Inner Triplet BPMs for HL-LHC

Design Review Summary and Cost Estimate

Assembly sequence beam screen

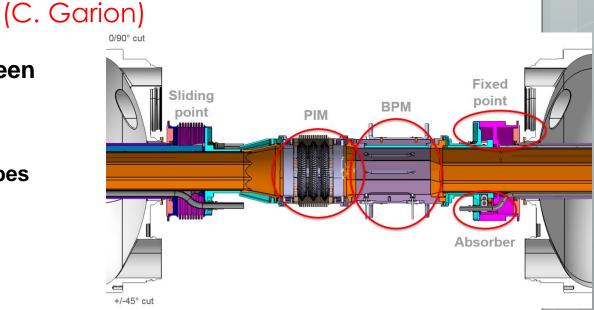
- 1. Beam screen installation:
 - 1. Beam screen assembly
 - 2. Insertion in the cold mass
 - 3. Bending of the cooling tubes (sliding point side)
 - 1. Fixed point
 - 2. Sliding point
- 2. Cryostat completion
- 3. Beam vacuum line finishing
 - 1. aC coating
 - 2. BPM assembly
 - 3. Cooling tube connections

Beam Screen discussion

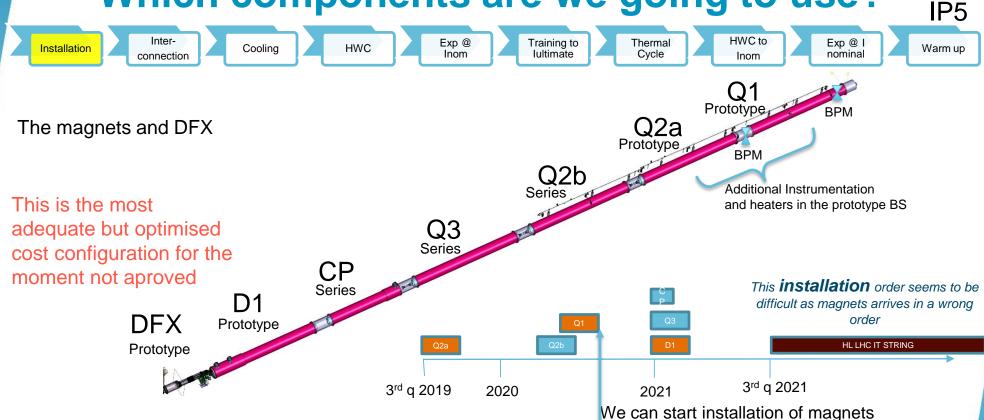
- Can the BPM/beam screen be installed together as in the LHC arc? Answer after the review by Cedric: No Problems:
 - The BPM opposite cooling tube bending requires that the beam screen is pushed over its nominal position in the cold bore
 - Consider beam screen weight and BPM fragility (Not k.o. criteria)
- Following the beam screen offset shown by Cedric, an optimum position of the BPMs should be found

BPM installation and alignment 4

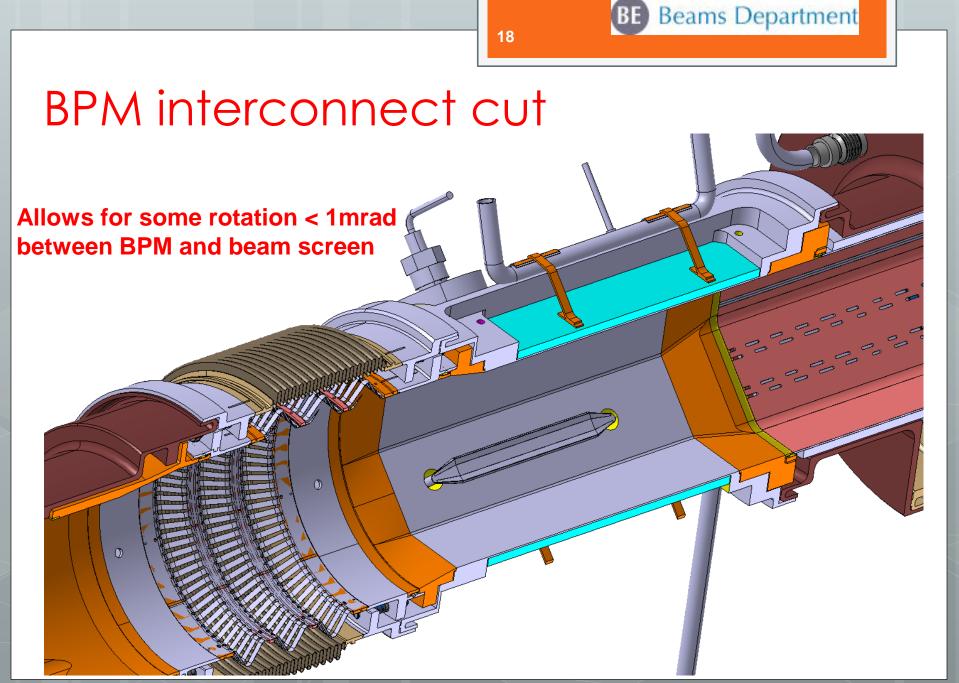
Position must be better than 0.5 mm wrt cold bore axis BPM start = Beam Screen end (+/- 0.2 mm)

Perpendicularity of the welding plane better than 0.2 mm wrt cold bore axis

Rotation better than 1 mrad wrt to cold mass plane
